# SERVICE BULLETIN

## SB1213

<b>ADDRESSEES</b>	: ABC Customer Care and Parts Source
<b>COACH/BUS MODEL</b>	: C2045, T2140, T2145
<b>BULLETIN TYPE</b>	: Product Improvement
<b>SECTION/CHAPTER</b>	: Section 11 – Body and accessories Chapter 10.10 – Windshield wipers & washers
<b>DATE</b>	: January 18, 2008
<b>SUBJECT</b>	: <b>DOGA wiper motor change</b>
<b>TERMS &amp; CONDITIONS</b>	: For units covered by the Van Hool normal warranty, the regular terms and conditions apply.

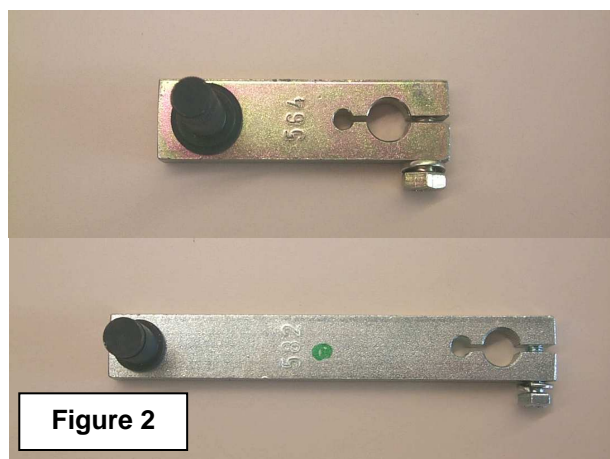
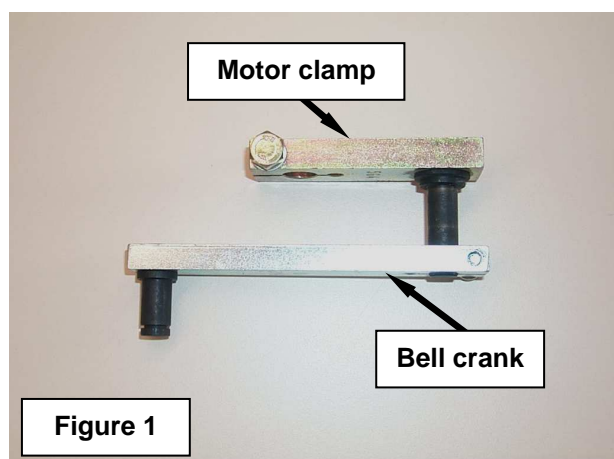
Doga, who are the manufacturers of the windshield wiper assembly, highly recommend that the motor clamp and bell crank (Figures 1 and 2) be replaced as a matter of course as these parts may have been damaged by the motor failure.

Not replacing these parts may result in failure of the wiper mechanism.
